W A L S E R
BLOOMINGTON TOYOTA
 4401 American Blvd, Bloomington, Minnesota

3/10/16	PRELIMINARY
4/20/16	CITY SUBMITTAL

SITE PLAN
 Sheet Number

1 SITE PLAN
A1 SCALE: 1" = 40'-0"

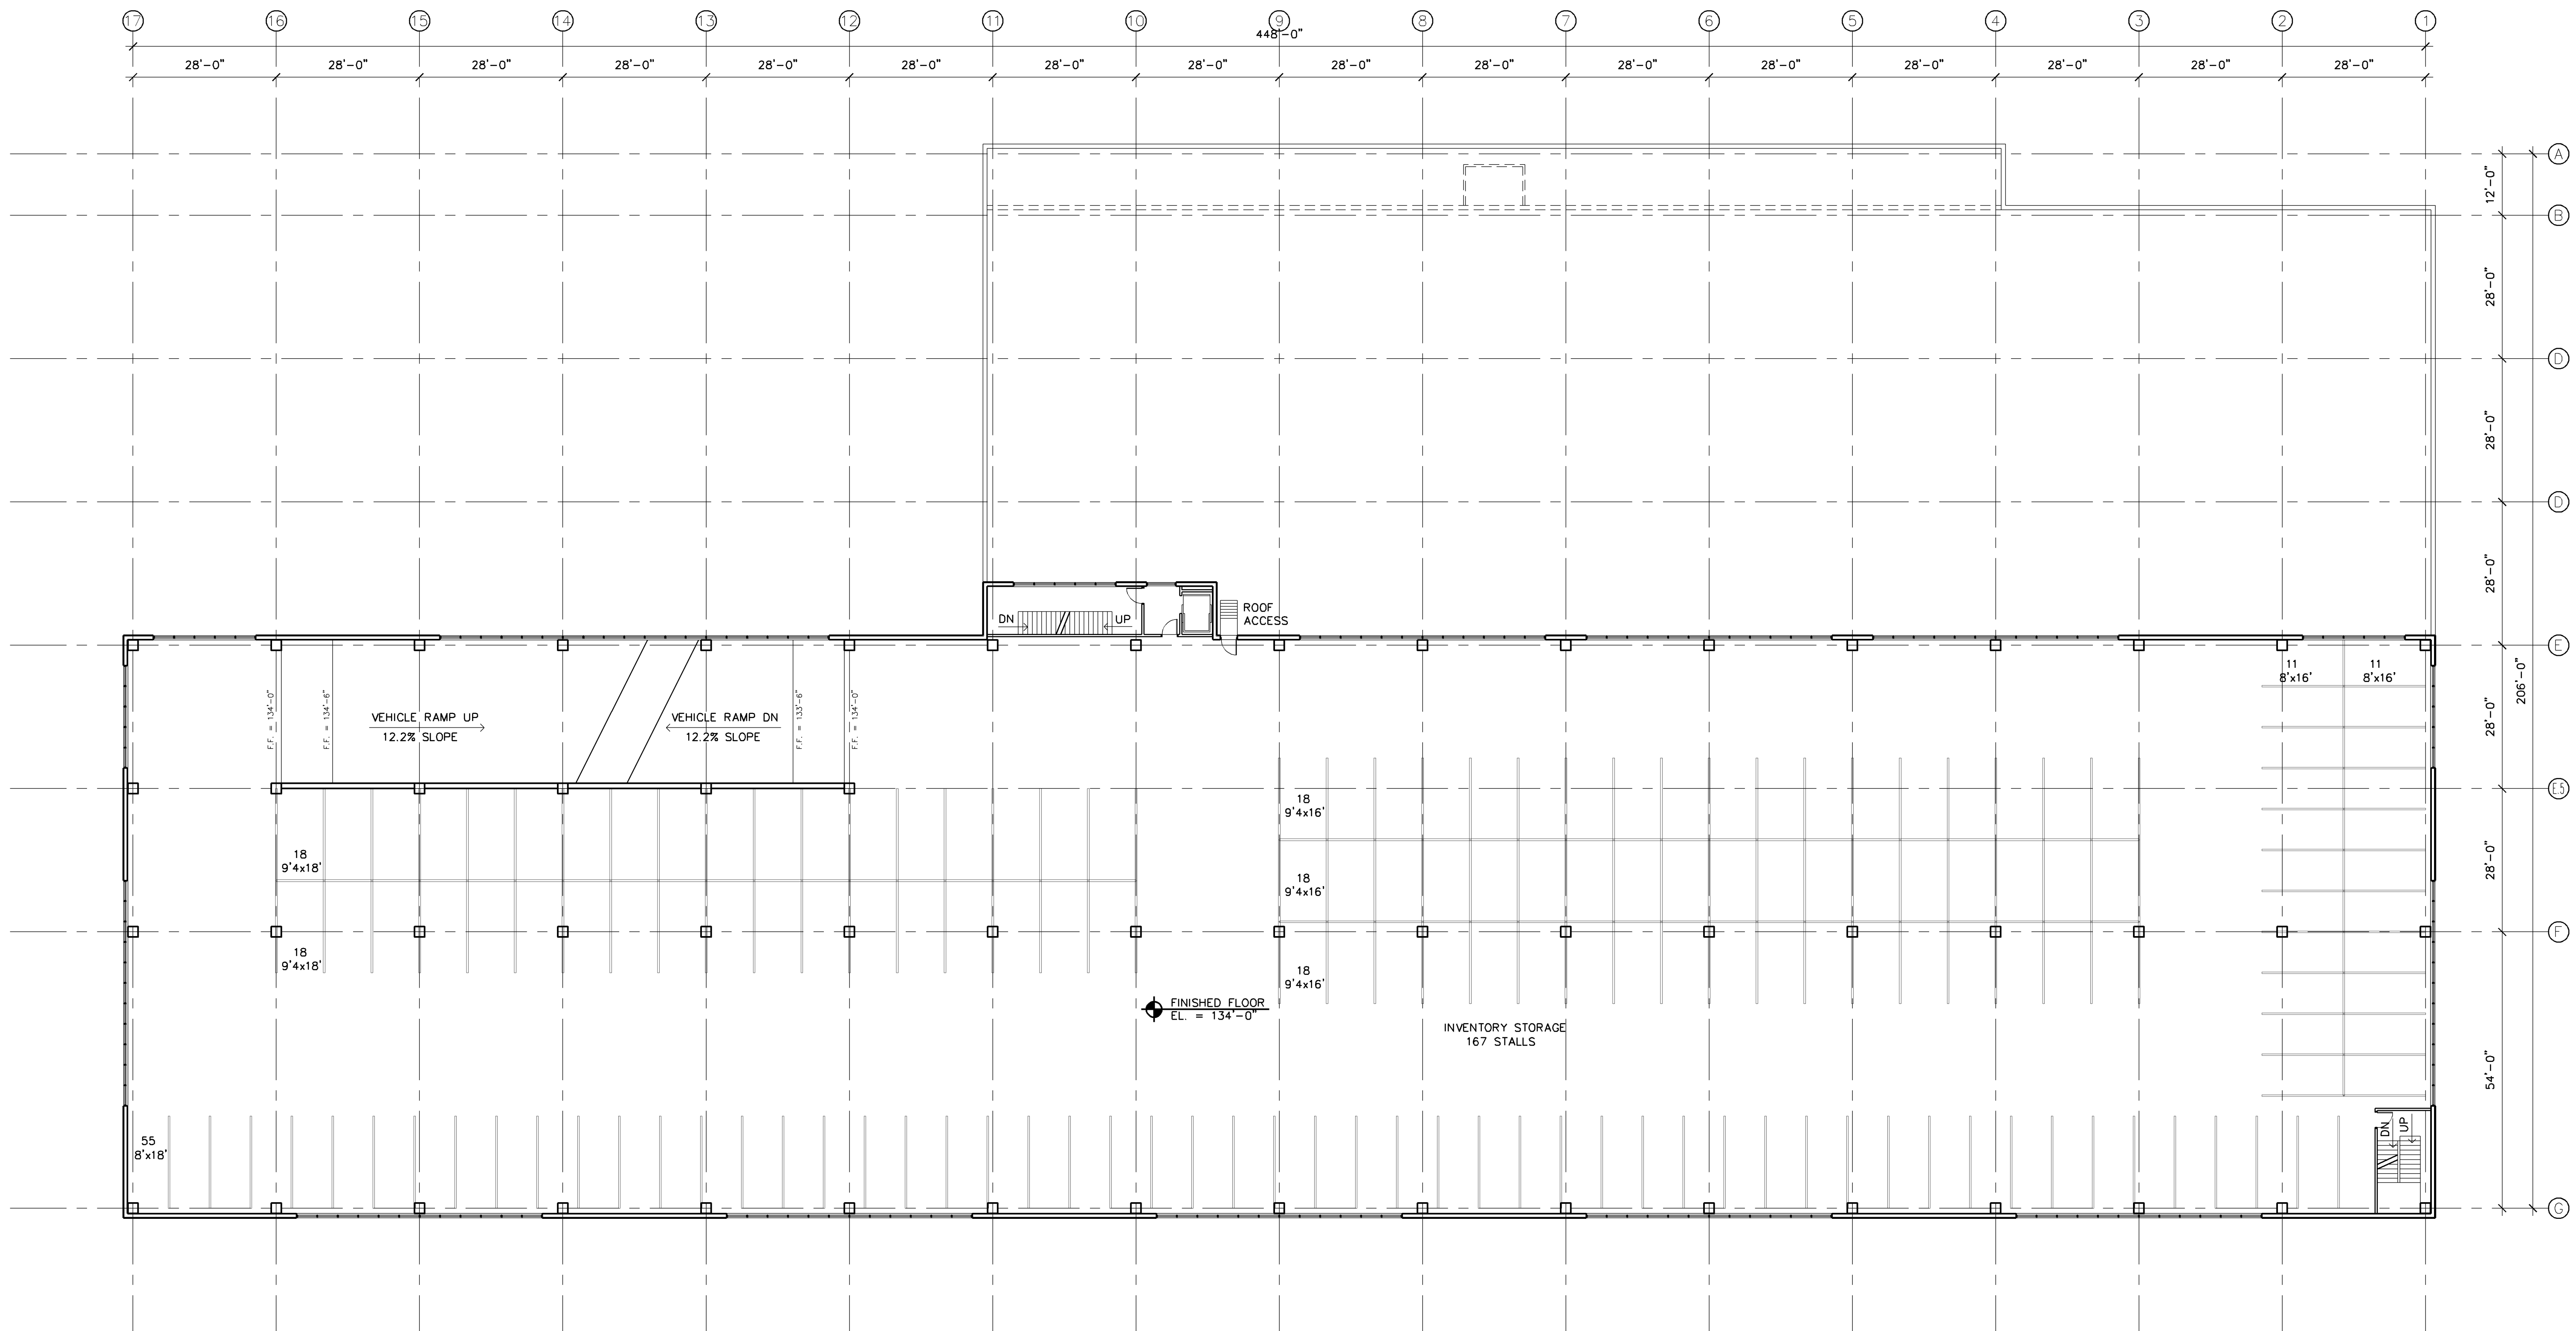
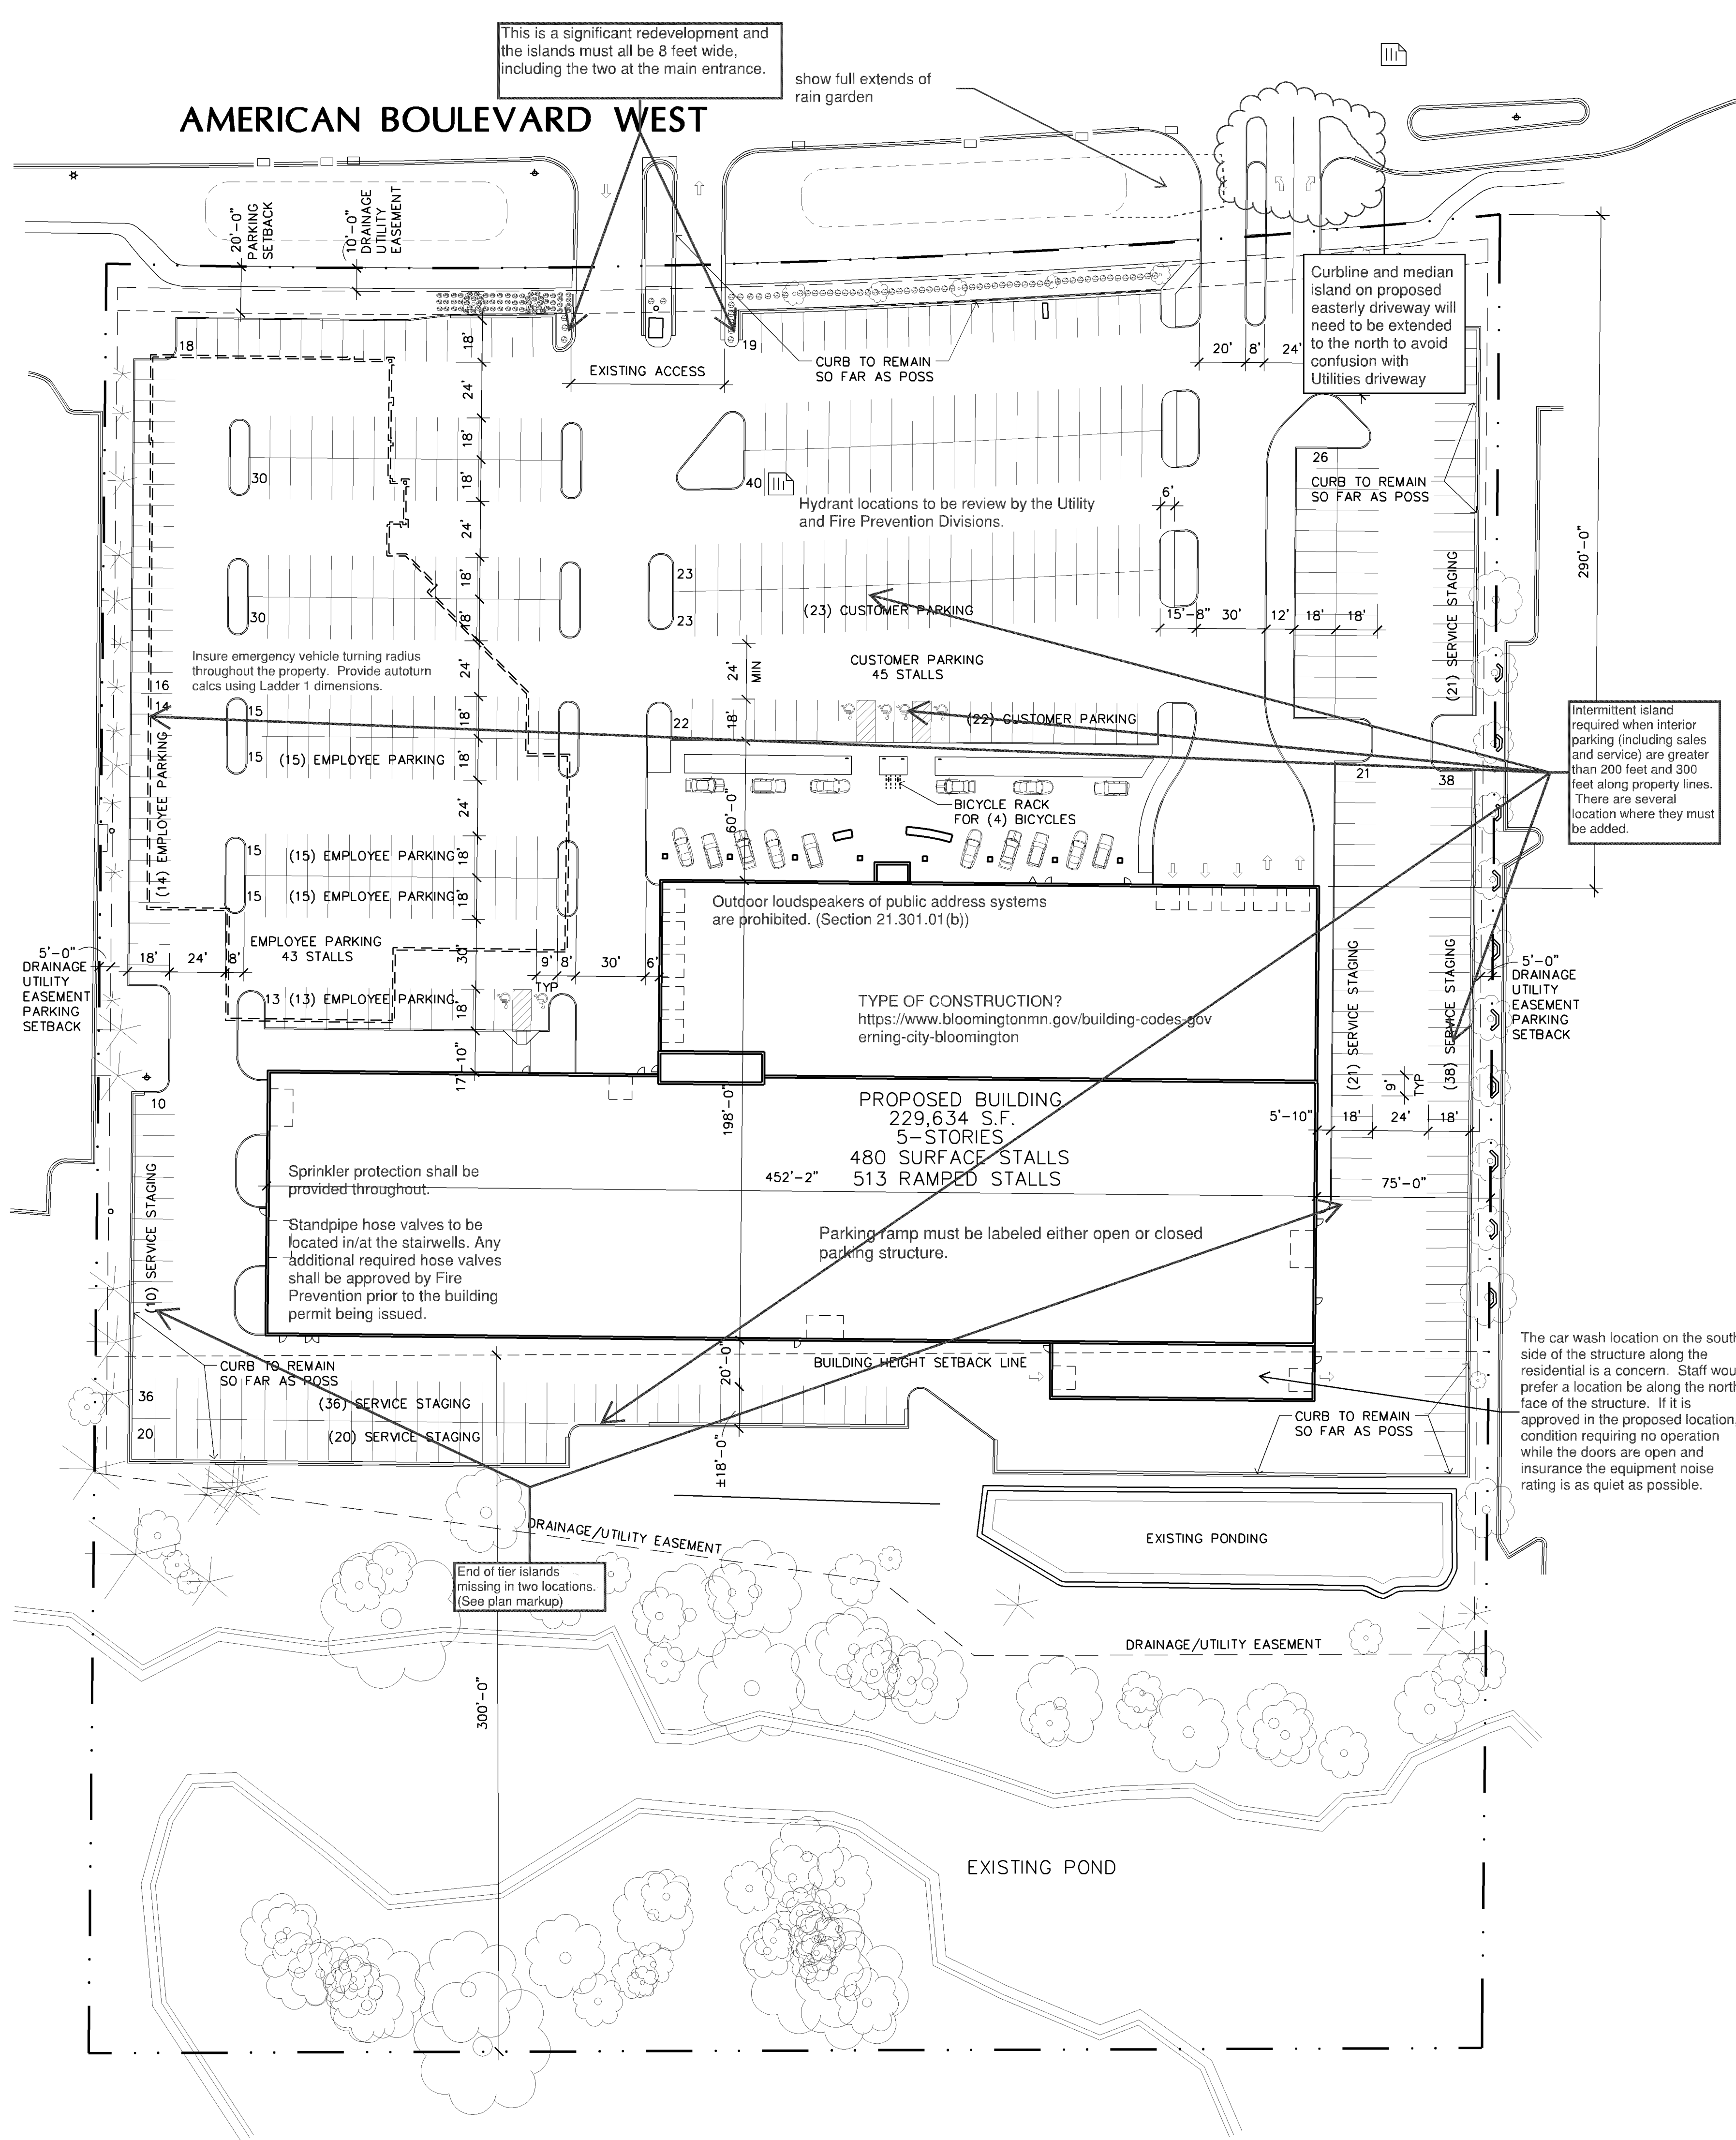
Identify locations where vehicle delivery will occur. This is to ensure the fire lane remains clear.

This is a significant redevelopment and the islands must all be 8 feet wide, including the two at the main entrance.

show full extends of rain garden

Curbline and median island on proposed easterly driveway will need to be extended to the north to avoid confusion with Utilities driveway

Hydrant locations to be review by the Utility and Fire Prevention Divisions.

Outdoor loudspeakers of public address systems are prohibited. (Section 21.301.01(b))

TYPE OF CONSTRUCTION?
<https://www.bloomingtonmn.gov/building-codes-governing-city-bloomington>

Sprinkler protection shall be provided throughout.
 Standpipe hose valves to be located in/at the stairwells. Any additional required hose valves shall be approved by Fire Prevention prior to the building permit being issued.

Parking ramp must be labeled either open or closed parking structure.

Intermittent island required when interior parking (including sales and service) are greater than 200 feet and 300 feet along property lines. There are several location where they must be added.

The car wash location on the south side of the structure along the residential is a concern. Staff would prefer a location be along the north face of the structure. If it is approved in the proposed location, condition requiring no operation while the doors are open and insurance the equipment noise rating is as quiet as possible.

End of tier islands missing in two locations. (See plan markup)
